**ANNEX 1**  
**APPLICANT'S RESPONSE ON REQUIREMENT 15 (AIR NOISE LIMITS)**

**1. THE SOS' REQUEST**

**Figure 1**

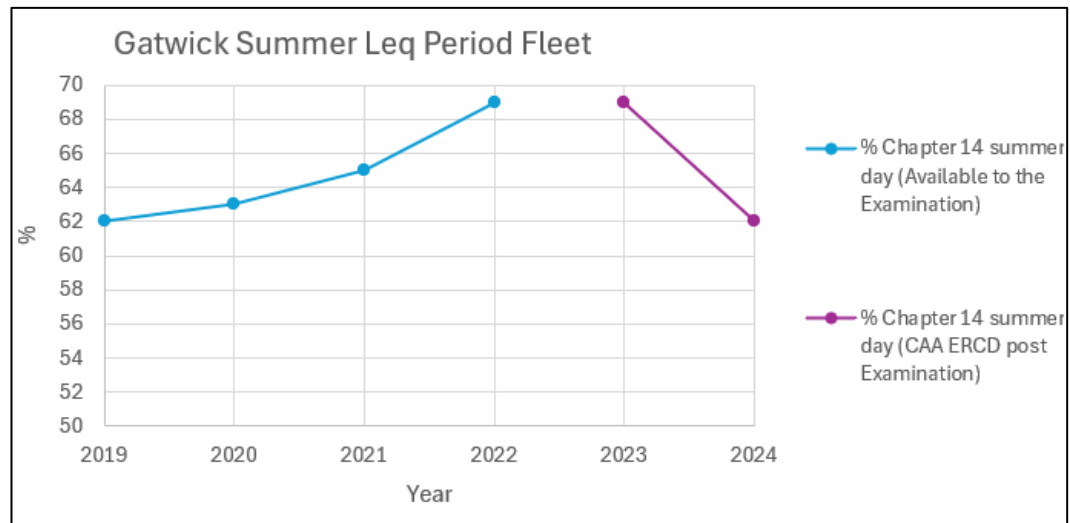
- 3.6 Since the close of the examination, the CAA ERCD has released summer 2023 actual contours (ERCD Report 2402<sup>1</sup>) and is currently finalising the summer 2024 contours<sup>2</sup>. The Applicant has prepared the following graph (Figure 1) showing the summer season daytime percentage of Chapter 14 aircraft operating at London Gatwick from the 2023 and 2024 data provided by the CAA ERCD (purple data points) along with the figures for 2019 to 2022 quoted by the ExA (blue data points) from the earlier data.

- 3.7 Clearly the upward trend noted by the ExA based on the data for 2019 to 2022 available to the ExA during the examination (though not presented to the examination or the Applicant) has since reversed, so that according to the latest analysis from the CAA ERCD the fleet in summer 2024 had the same percentage of Chapter 14 aircraft as in 2019.

- 3.8 During COVID the aircraft that airlines took out of operation and grounded tended to be the older, noisier and less efficient types of aircraft, so the fleet operating tended to show quieter aircraft than pre-COVID. The fleet has changed for a number of reasons in the subsequent years. In summer 2024, air transport movements ("ATMs") were back close to 2019 levels. Relatively older, noisier aircraft have returned to service, and the percentage of Chapter 14 aircraft has decreased back to 62% (on the CAA ERCD's provisional data), the same as in 2019. This is clear evidence from the CAA ERCD's analysis of the actual fleet flown each summer season that the overall fleet at Gatwick in 2024 has not transitioned to quieter types compared to the 2019 baseline.

**Figure 2**

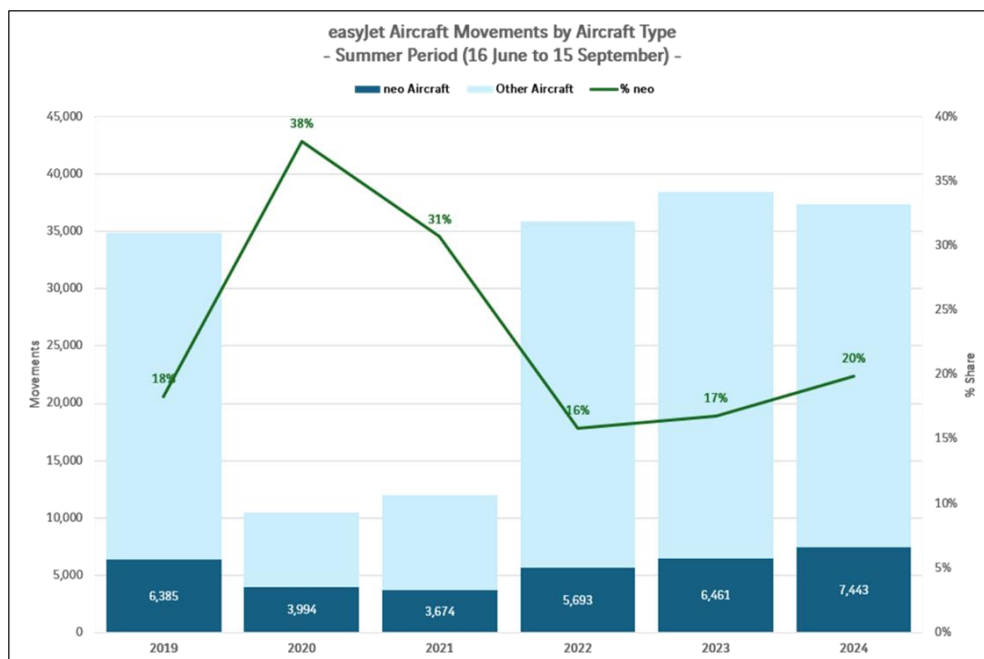
- 3.9 Further evidence of how this has happened in practice can be seen by an analysis of easyJet's fleet in operation at Gatwick over this period, as follows:

- 3.10 Figure 2 clearly shows how, in summer 2020 when the pandemic had struck, easyJet removed its older current generation aircraft (A319, A320) from operation and kept a much greater proportion of its next generation fleet (A320 NEO and A321 NEO) in operation. In summer 2020 38% of its fleet was NEO. As traffic increased in the following years, current generation aircraft were returned to service and NEO percentage gradually reduced to 20%, which is just 2% higher than in 2019. EasyJet accounts for approximately 50% of Gatwick traffic, so this further explains the apparent rapid fleet transition observed by the ExA from 2019 to 2022 that was reversed from 2022 to 2024.
